Access Compliance Report

Public Rights-of-Way

Intersection ID: 25269	Main Street: REA_RD	Cross Street: SUMMER_GATE_DR	Location: NW
ADA ID: 04CACE11B293	Ramp Type: BlendTrans2	Initial Pass/Fail: Pass	Overall Compliance: No
		Severity Score: 0

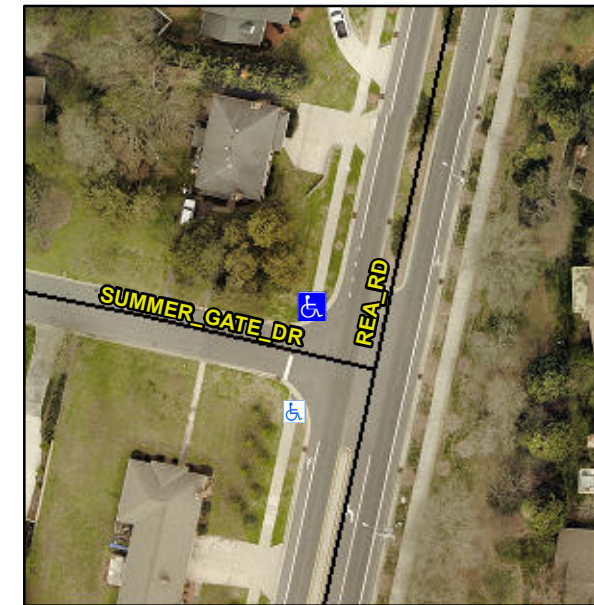
Not Found, R305.2

X Walk 1 X Slope (%)	0.7		X Walk 2 X Slope (%)	0.8
N/A	Ramp inside XWalk1?	N/A	N/A	Ramp inside XWalk2?	N/A
	Road Slope (%)	0.1		Clear Space?	Yes
	Road X Slope (%)	1.7	N/A	Clear Space to XWalk (in)	N/A
Yes	Any Obstructions?	No	Yes	Storm Grate/Utility Hazard?	No
	Obstruction Type			Storm Grate/Utility Type	
		N/A			N/A
			Yes	Surface Condition? (G/P)	Good
			No	Curb Slope (%)	9.0

Remove & Replace Curb Ramp With Two New Directional Ramps or Equivalent.
